4.13.17 Long Term Rehabilitation Development and Performance

Submissions: SIG3, SIG6, SIG8, SIG22

4.13.27 Coalpac Rehabilitation Record

Figure 11
Conceptual Design for Revised Invincible Colliery Site Access Intersection

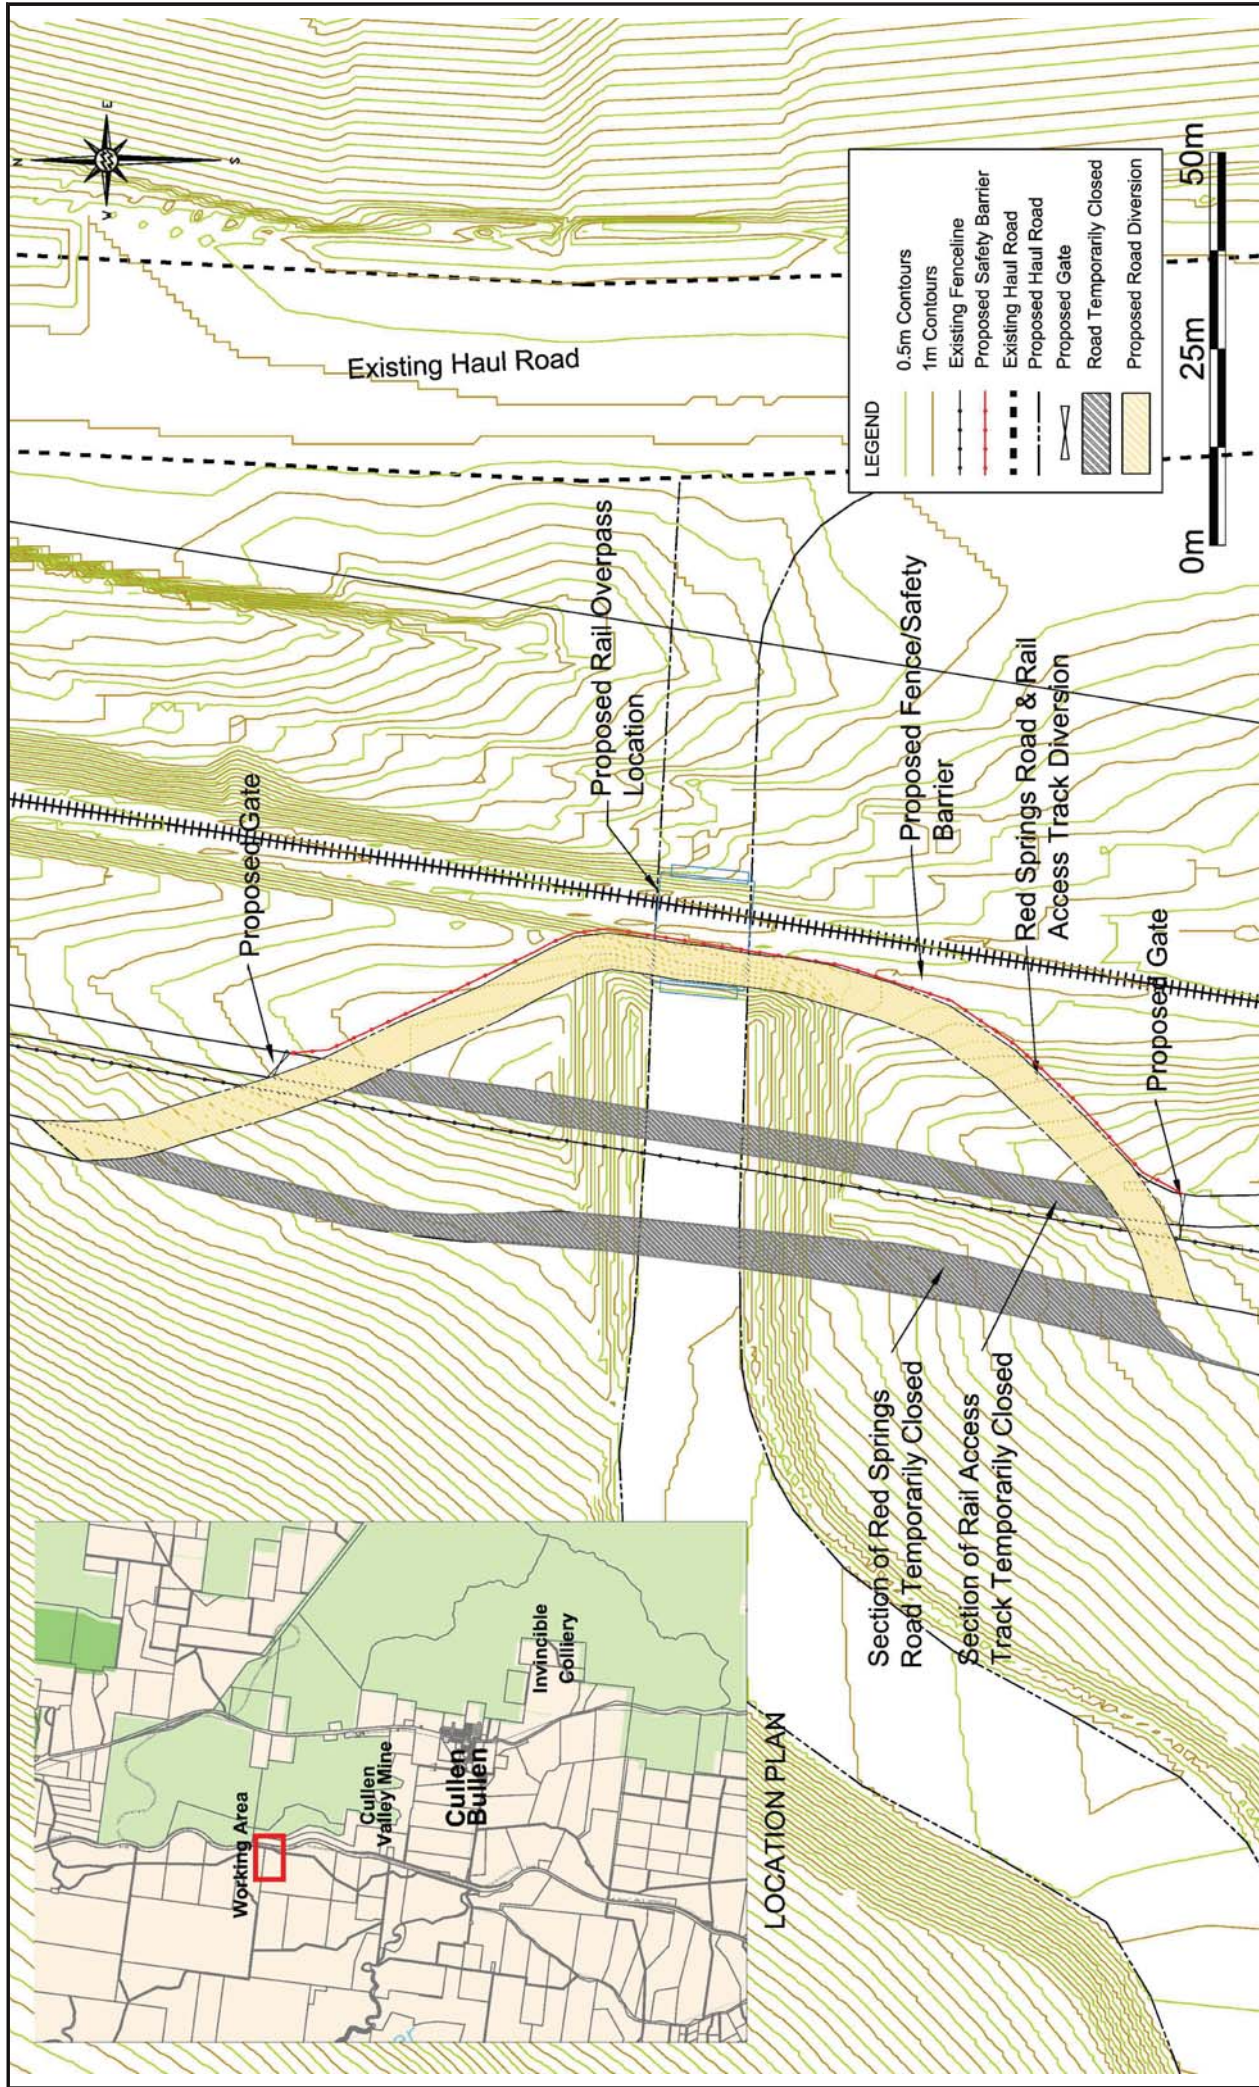
It is understood that the existing intersection was modified/widened to incorporate turning lanes into Invincible Colliery and Ivanhoe North Colliery (Ivanhoe North) at the time of commencement of operations at Ivanhoe North. In addition, traffic flow was changed to prevent trucks turning right onto the highway from Ivanhoe North. In lieu of making a right hand turn, trucks leaving the Ivanhoe North site are obliged to drive directly across the Castlereagh Highway into the Invincible Colliery site, negotiate the internal road network within Invincible Colliery and then make a left hand turn onto the Castlereagh Highway from the dedicated outgoing roadway access on the eastern side of the intersection.

The proposed Castlereagh Highway overpass to the north of Cullen Bullen will remove coal truck traffic from the Private Haul Road entrance on the Castlereagh Highway to the Invincible Colliery site generated under the conditions of the existing Cullen Valley Mine approval (DA 200-5-2003). Until this overpass is completed (anticipated completion is by Year 2 of the Project), there will be limited truck traffic from the Cullen Valley Mine to the ICPP via the Castlereagh Highway (these trucks would make a left hand turn from the Castlereagh Highway into the Invincible Colliery site). It is anticipated that truck movements would not exceed four one way movements per hour, up to the date of completion of the Castlereagh Highway overpass.

1. The final proposed option, being: Diversion across the existing rail access track and under the required proposed rail overpass location. This will provide access from the existing Cullen Valley Mine haul road on the eastern side of the railway line to the western Hillcroft mining area. The proposed diversion will incorporate gates at the two locations where the diversion crosses the Rail Access Track. The layout of this proposed option is shown in **Figure 12**.
2. Culvert under the new east / west haul road: this option was found to be cost prohibitive; or
3. Closure of Red Springs Road for a period of up to 3 years whilst mining at Hillcroft: This was not the preferred option of the LCC (both owner and manager of the road).

COALPAC CONSOLIDATION PROJECT		Figure 17	
Hansen Bailey		Coalpac Pty Ltd	
Conceptual Wallerwang - Gwabegar Rail Overpass Section Locations		Cad File: 08541B.dwg	
Date: 31.07.12		Drawn: JD

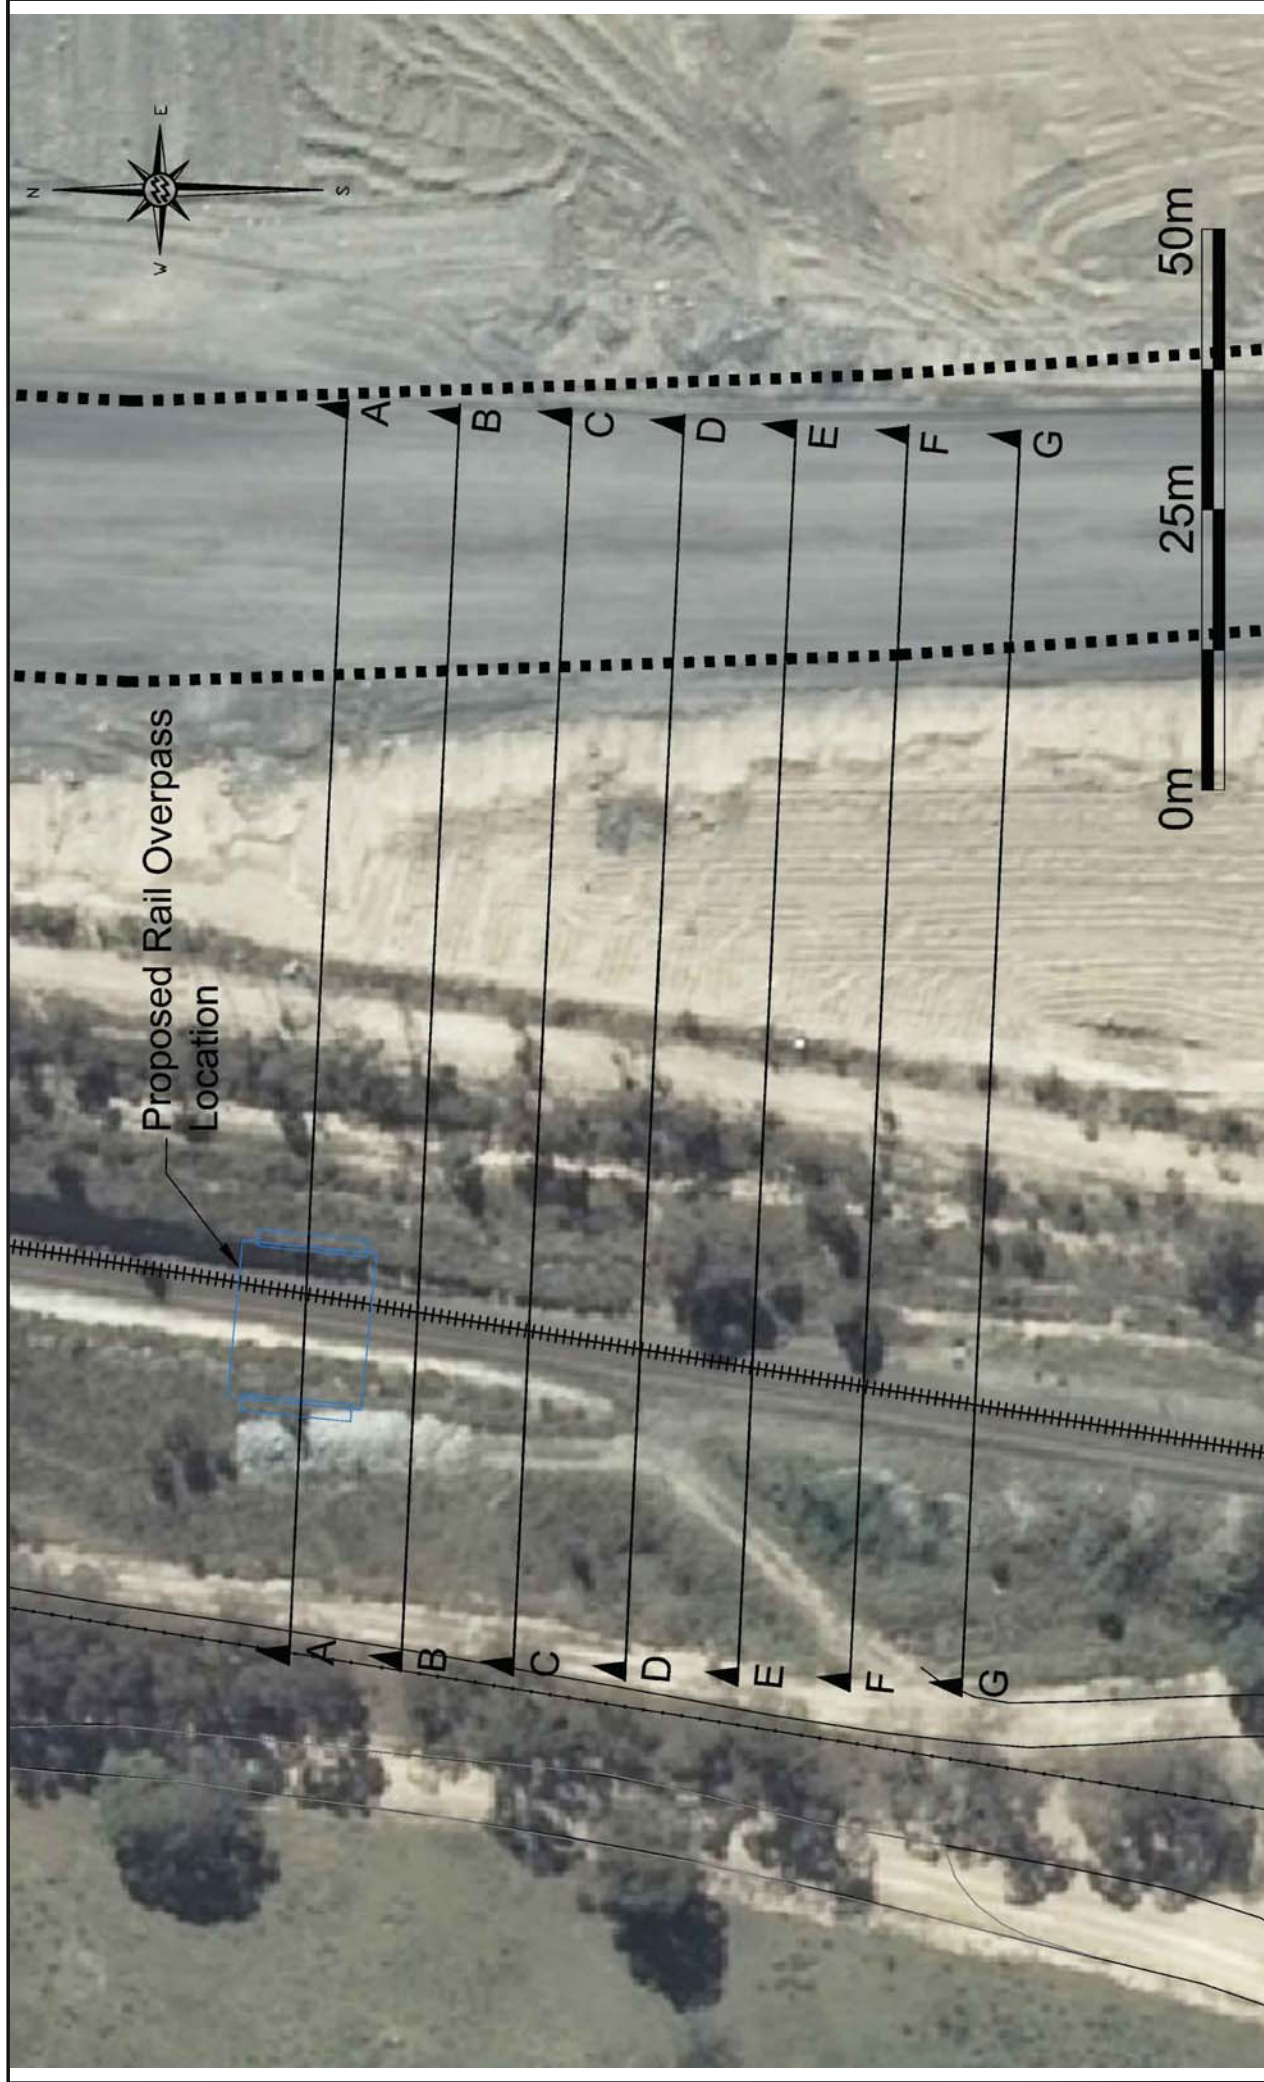
CRIA noted that the EA did provide detail on the location and configuration of the proposed construction and operation of a bridge and haul road across the Wallerawang – Gwabegar Rail Line. The CRIA submission also noted that new level crossings (for access roads) would need to be approved for the Project.

Noted. Detail on the proposed Wallerawang – Gwabegar Rail Crossing is included in **Figure 16** to **Figure 18**.

Coalpac has commenced consultation with CRIA on this infrastructure and will pursue the relevant agreements. A site meeting and inspection of the proposed sites of the bridge and siding were held with CRIA and John Holland Rail representatives on 12 May 2012. The issue of access road level crossings was discussed at the site meeting, and Coalpac proposed closure of the eastern rail access roadway at the location of the proposed bridge with routing of the western rail access roadway beneath the bridge. The rail parties agreed and expressed a preference for maintaining access on the western roadway at the expense of the eastern roadway.
